**SUBJECT: NORTH ANNA POWER STATION – NRC OPERATOR LICENSE
EXAMINATION REPORT 05000338/2016301, 05000339/2016301**

Report No.: 05000338/2016301, 05000339/2016301

Facility: North Anna Power Station, Units 1 & 2

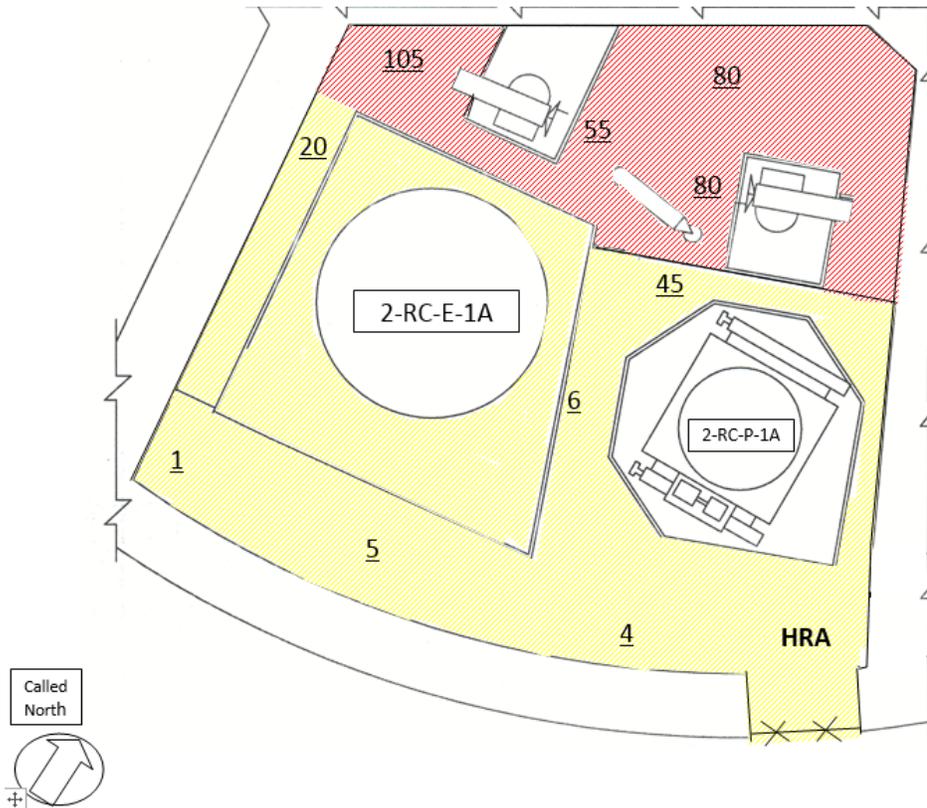
The licensee contended that RWP Task 1 or Task 2 were both acceptable for manually closing the "A" Cold Leg Loop Stop Valve. Specifically, the licensee contended that Task 1 was also acceptable because RP-AA-274, Radiation Work Permits, Step 5.16.5.d included an allowance for health physics (HP) supervisors to change the electronic dosimeter dose rate alarm, if necessary. The licensee contended that the JPM should be revised to allow either RWP Task 1

or Task 2 to be selected, and the corresponding stay times (80% of RWP dose allotment) must be 6 minutes and 12 minutes, respectively.

On the survey map, the "A" Cold Leg Loop Stop Valve hand wheel was the valve located closest to the reactor coolant pump, 2-RC-P-1A, and the dose rate at the hand wheel was 80 mr/hr.

Five of the twelve applicants chose Task 1. However, the JPM answer key indicated that Task 2 was the correct task because the electronic dosimeter dose rate alarm for Task 1 was only 50 mr/hr, which meant that the electronic dosimeter would continuously alarm at the "A" Cold Leg Loop Stop Valve hand wheel location if Task 1 was selected.

The applicants told the examiners that, although the Task 1 electronic dose rate alarm set point (50 mr/hr) was less than the dose rate at the "A" Cold Leg Loop Stop Valve hand wheel (80 mr/hr), the NOTE in the worker instructions for Task 1 indicated that the electronic dosimeter dose rate alarm was an expected alarm, and said that if the electronic dosimeter continuously alarmed, then the worker was required to exit the area and request health physics personnel to adjust the electronic dose rate alarm set point to a higher value. RP-AA-274, Radiation Work Permits, Attachment 5, Briefing Attendance Roster, included a column labeled "Revised ED Alarm Set point", and stated that electronic dosimeter alarms can be revised from default settings only if the RWP task is controlled by entering Plan ID numbers in the HIS-20 and authorized by HP Supervision.

On the other hand, the entrance to the Unit 2 Containment, 262' elevation "A" RCP Motor Cube was a High Radiation Area, as indicated on the survey map with the "HRA" designator at the doorway. High Radiation Areas are defined as areas with > 100 mr/hr dose rates, and one of the motor cube areas' dose rate was 105 mr/hr, which was consistent only with RWP Task 2. However, RWP Task 1 also indicated that maximum posted area that could be entered was a Locked High Radiation Area, which also seemed to conflict with the title of Task 1 "Dose rates less than 100 mr/hr." Further discussion with the licensee's health physic staff indicated that entry to a Locked High Radiation Area, as stated in RWP 16-2229, Task #1, was permissible, and the reason this was permissible was because the lower electronic dosimeter set points associated with Task 1 were used as an ALARA tool at North Anna, even if a Locked High Radiation Area was entered, since not all locations within the Locked High Radiation Area were 1000 mr/hr. Therefore, this same logic applied even though the survey map had the "HRA" designator at the motor cube doorway and one of the areas' dose rate was 105 mr/hr.

Because the title of Task 1 was “Dose rates < 100 mr/hr”, the applicants were placed into a confusing situation during the administration of the JPM because the dose rate near the valve hand wheel was 80 mr/hr, which aligned with the title of Task 1, but the electronic dosimeter rate alarm set point was only 50 mr/hr. The Task 1 Work Instruction NOTE caused further confusion because it implied that some electronic dosimeter rate alarms were expected alarms when set points were conservative. Furthermore, RWP Task 1 indicated that maximum posted area that could be entered was a locked high radiation area, which also conflicted with the title of Task 1 “Dose rates less than 100 mr/hr.” Based on these items, the licensee’s recommendation to revise the JPM answer key to accept either Task 1 or Task 2 was accepted.

The licensee's recommendation was accepted.

Therefore, the revised answer key to allow either Task 1 or Task 2 did not invalidate the JPM because the discriminatory and operational validity of the remaining portion of the JPM was still acceptable for the administrative portion of the operating exam.
